Reference: University of Maryland, Maryland University Training Reactor (MUTR)
Docket No. 50-166, License No. R-70
Request for Additional Information (RAI) Regarding Maximum MHA Dose

Response to the NRC RAI regarding dose to the general public in the event of a Maximum Hypothetical Accident (MHA)

FIGURE 7.2:

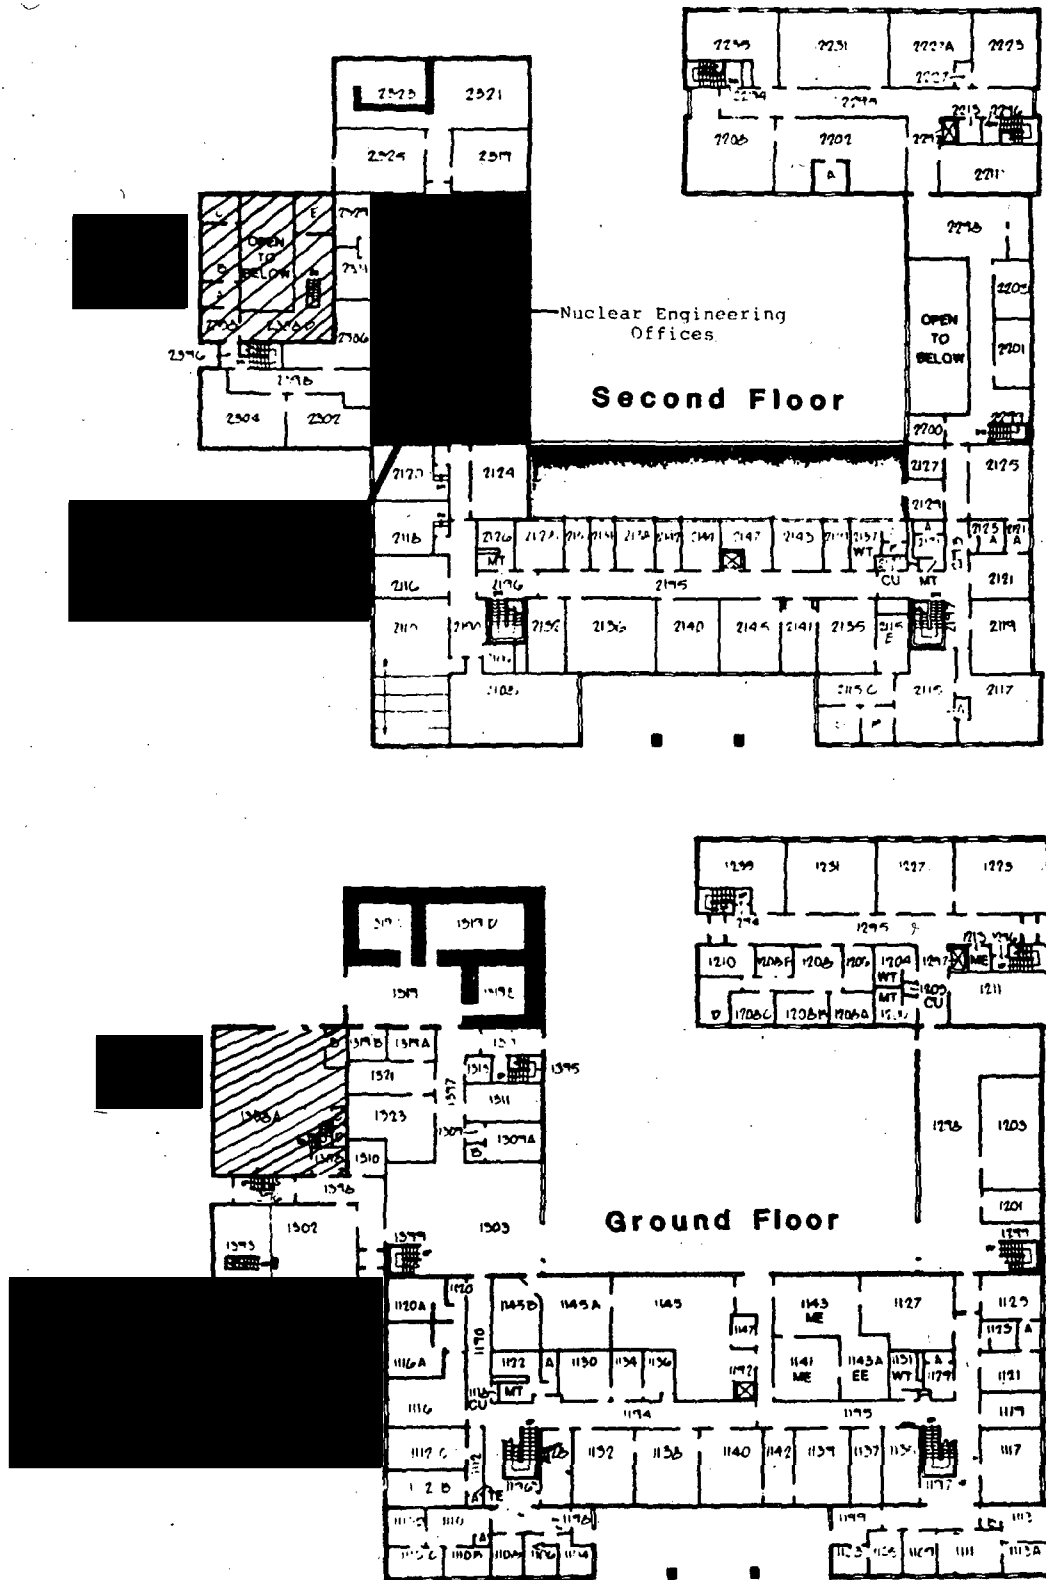
and assemble as shown on Figures 7.1 and 7.2. For a Class 2 emergency, the Chemical and Nuclear Engineering Building shall also be evacuated by using the fire alarm. In a Class 2 emergency, the primary assembly area shown in Figure 7.2 is not used, and personnel will assemble at the secondary assembly area shown in Figure 7.2.
